**AMENDMENT ON TECHNICAL SPECIFICATION FOR COMPRESSED AIR SYTEM
PACKAGE
5 X 800 MW YADADRI TPS**

SPECIFICATION NO.: PE-TS-417-555-A001

AMENDMENT NO # 1

REV. NO. 00 DATE: 06/08/2018

DRAWING NO. PE-DG-417-555-A018

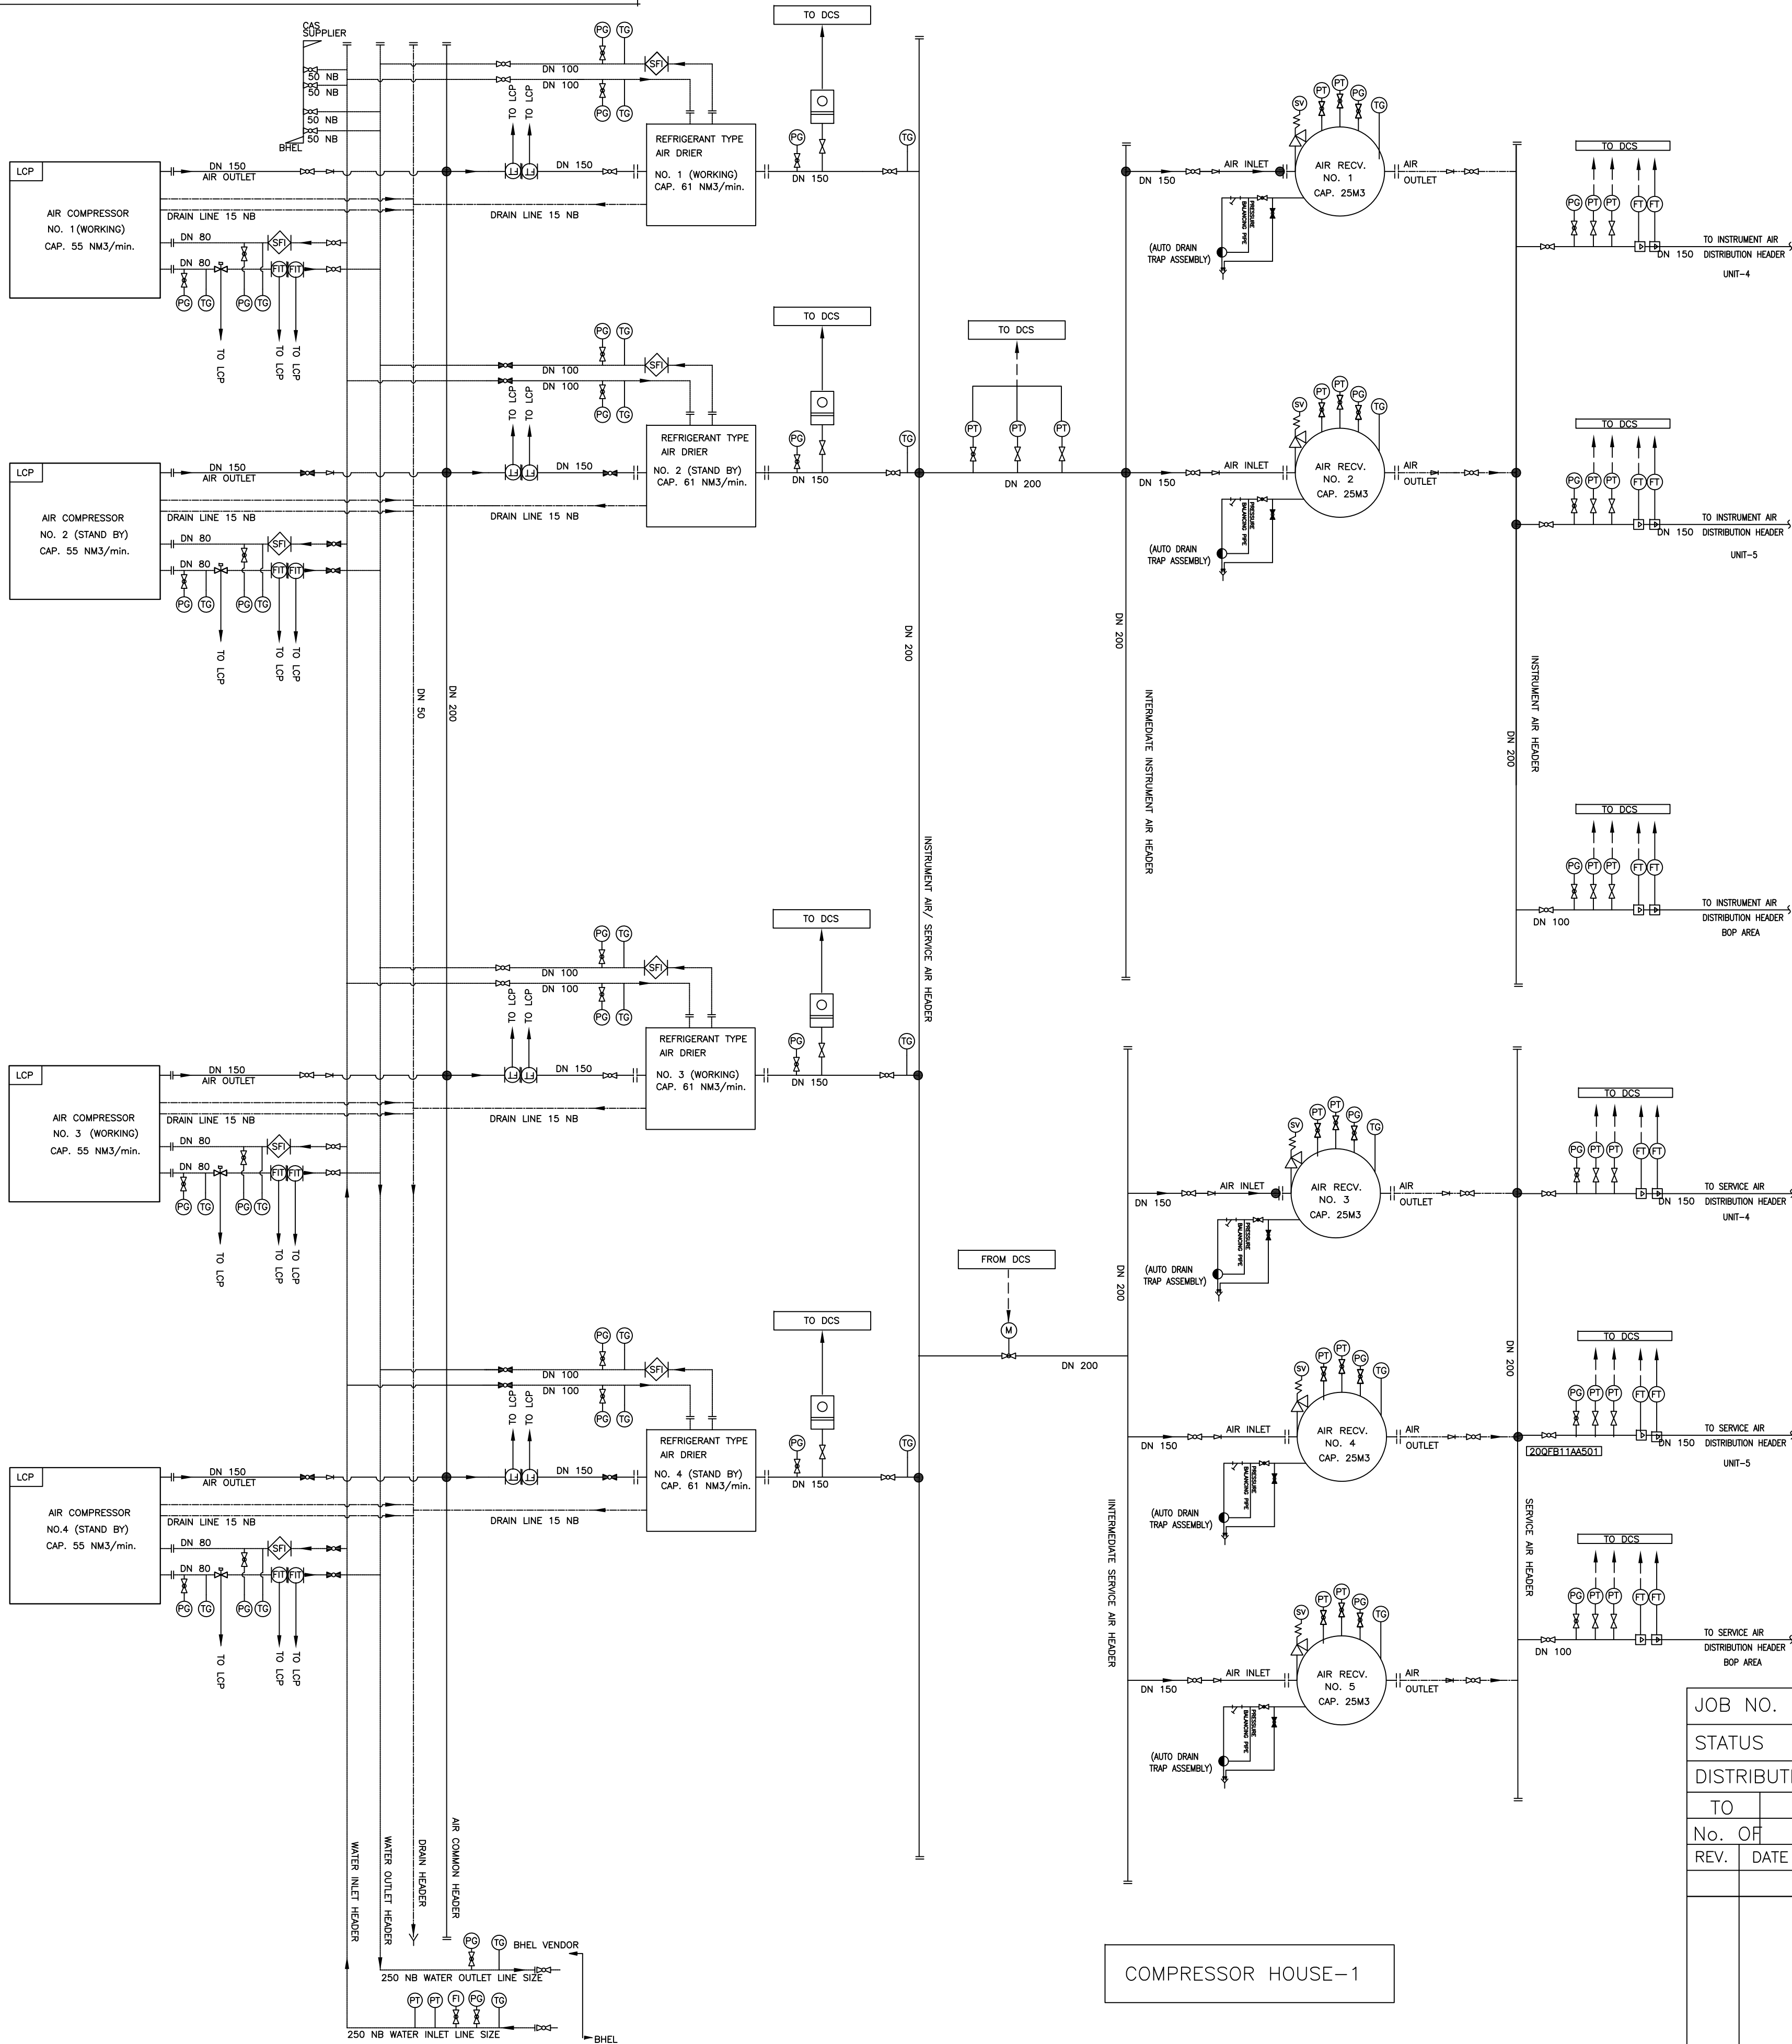
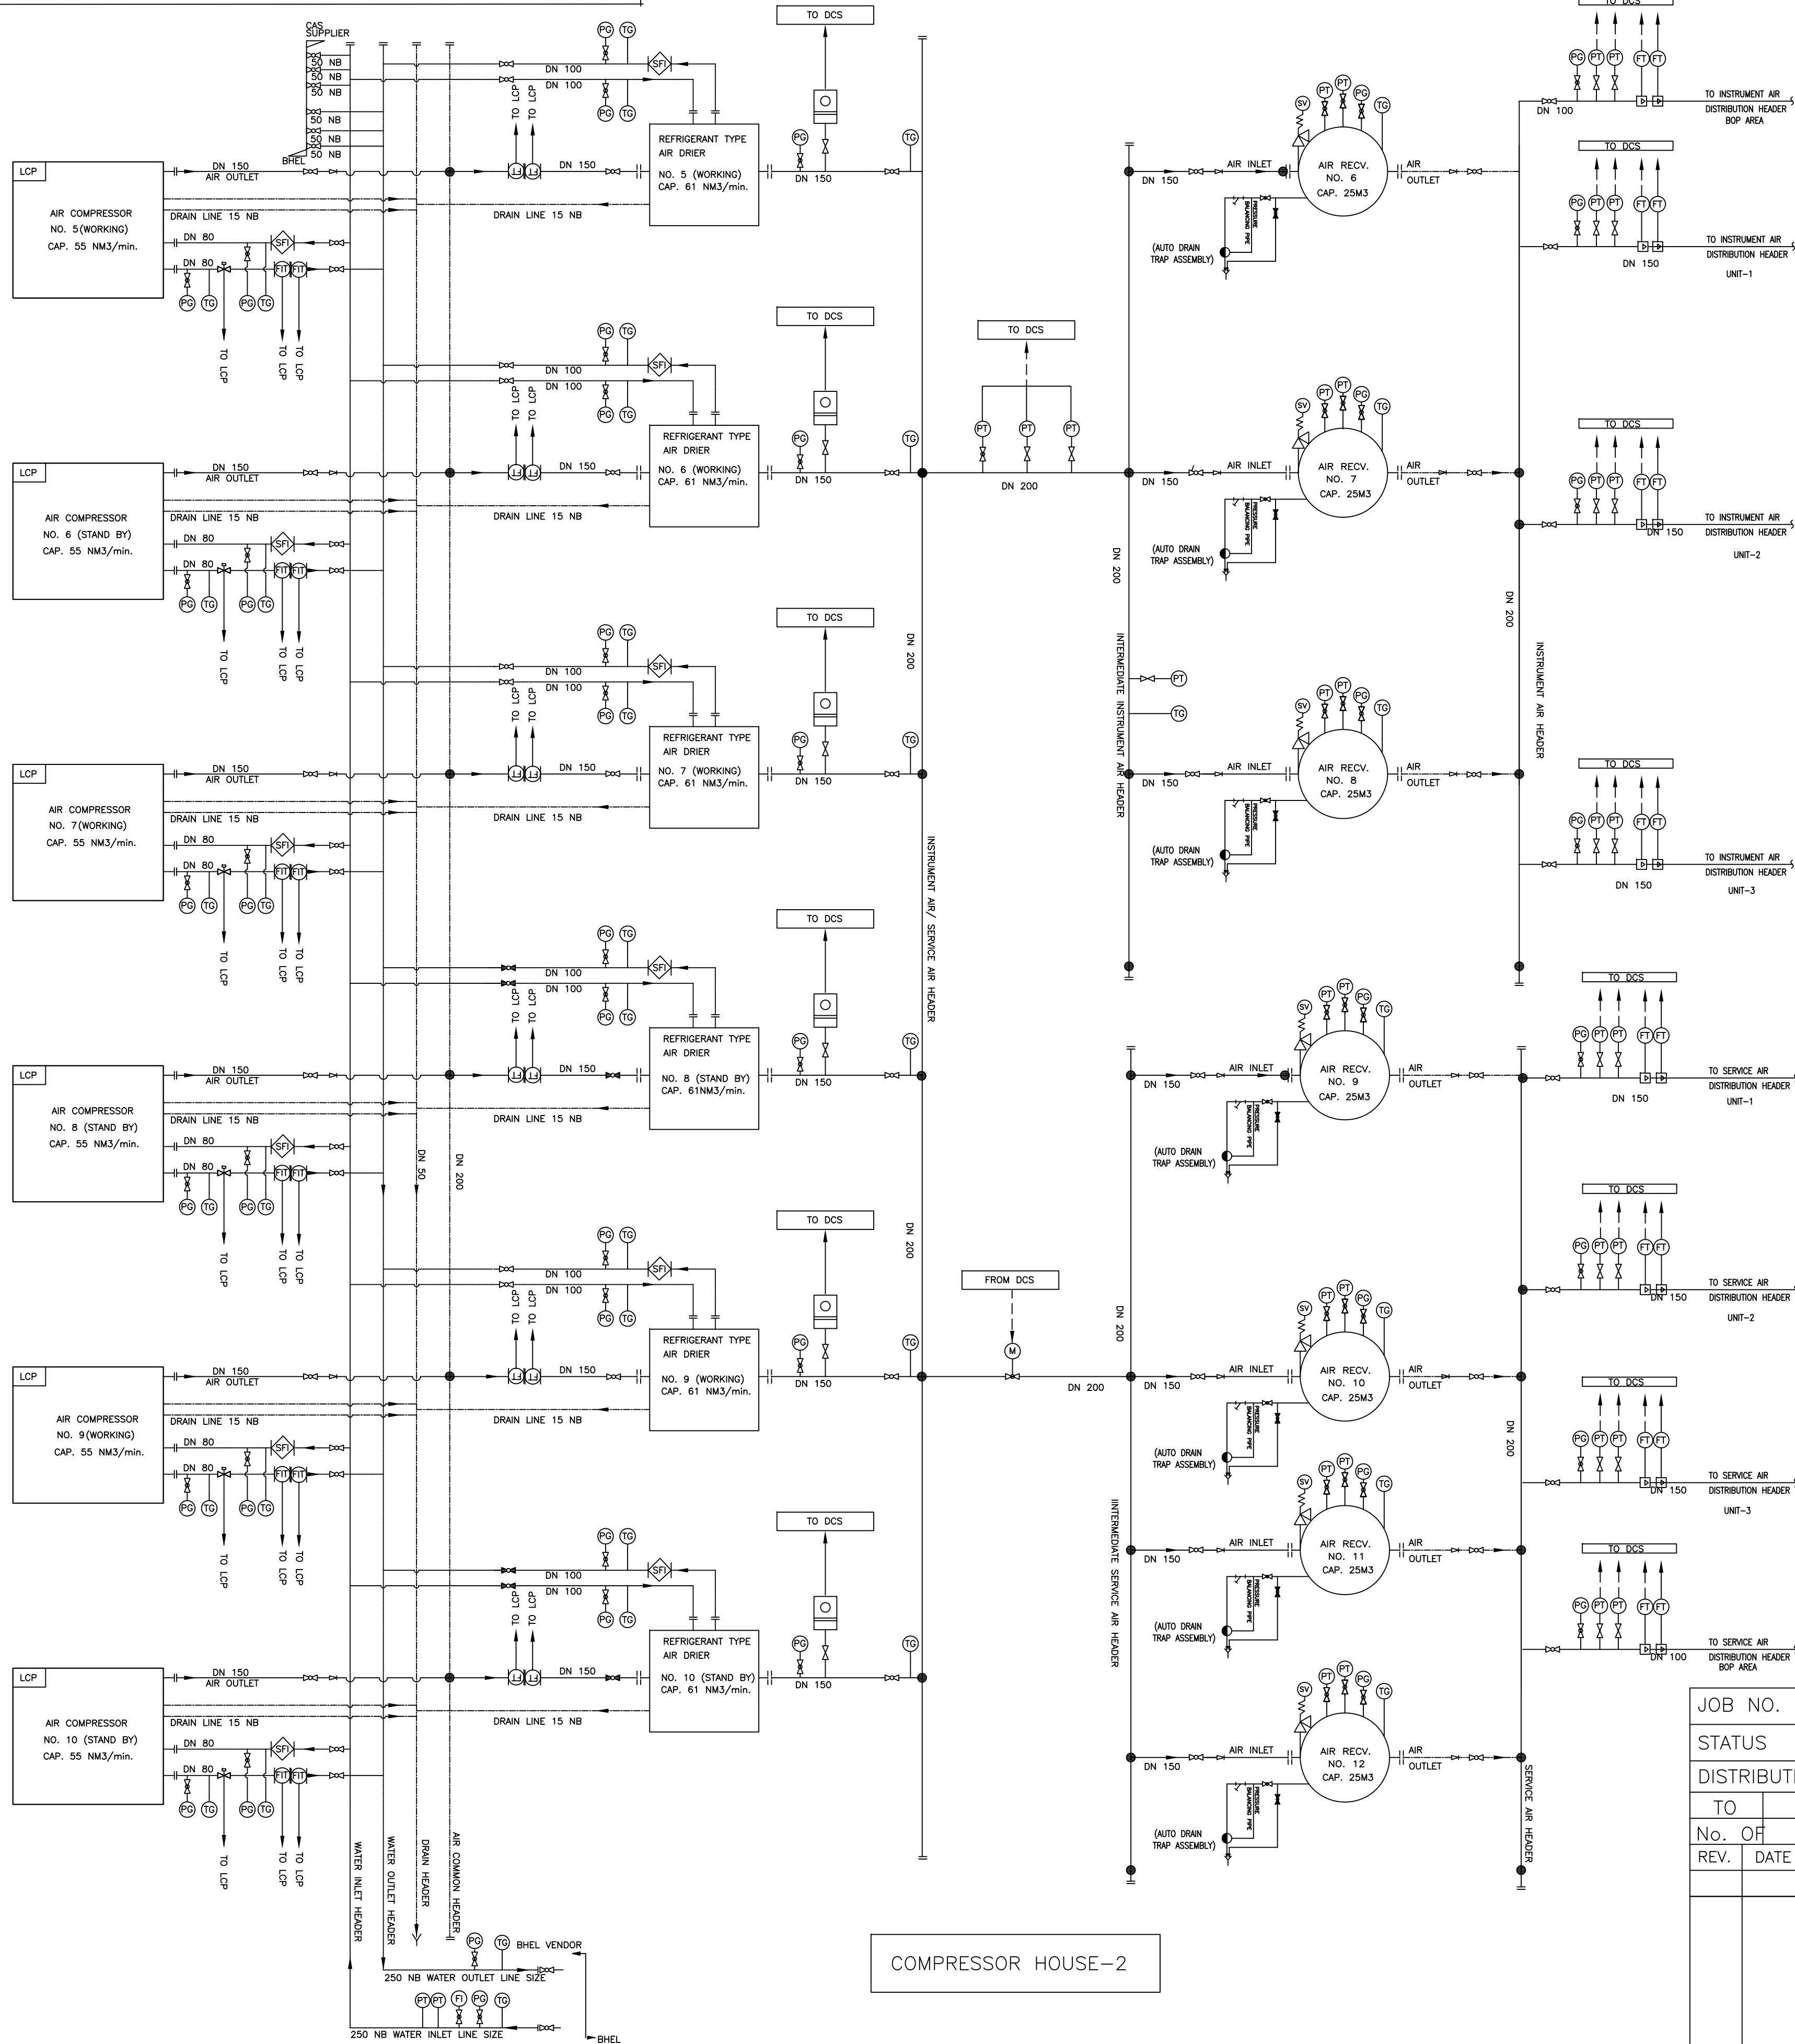
2.	IA	ANNEXURE-IV, INPUT DRAWINGS OF TENDER)	--	171-174	drawings 1. P& ID of compressed air system within compressor house (PE-DG-417-555-A018) 2. Compressor house layout (PE-DG-417-555-A015)	Revised drgs. are attached as annexure – A 1. P& ID of compressed air system within compressor house (PE-DG-417-555-A018) 2. Compressor house layout (PE-DG-417-555-A015)
